Process Change Notification

Title: MCC Introduces new lead frame for 0201 package

PCN#: 022021-1

Detailed difference as below:

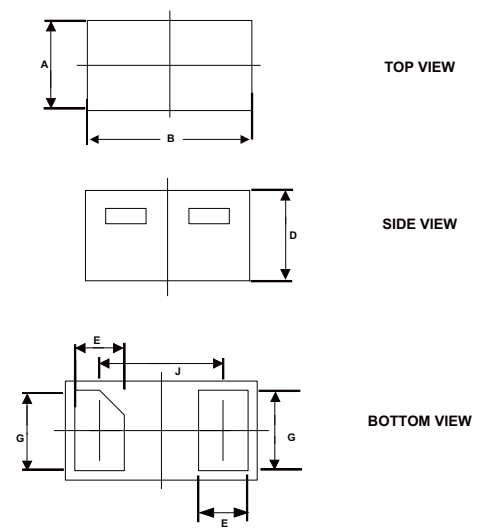
To solve our delivery issue of 0201 package, MCC has determined to add a new lead frame source. The outline still meet industrial standard and pls see below outline comparison for details.

Old

DIMENSIONS					
DIM	INCHES		MM		NOTE
	MIN	MAX	MIN	MAX	
A	0.011	0.015	0.270	0.370	
B	0.022	0.026	0.570	0.670	
D	0.011	0.013	0.275	0.340	
E	0.005	0.008	0.125	0.195	
G	0.009	0.012	0.225	0.295	
J	0.014	0.017	0.365	0.435

New

DIMENSIONS					
DIM	INCHES		MM		NOTE
	MIN	MAX	MIN	MAX	
A	0.011	0.015	0.270	0.370	
B	0.022	0.026	0.570	0.670	
D	0.011	0.013	0.275	0.340	
E	0.005	0.008	0.125	0.195	
G	0.009	0.012	0.225	0.295	
J	0.014		0.365		TYP.
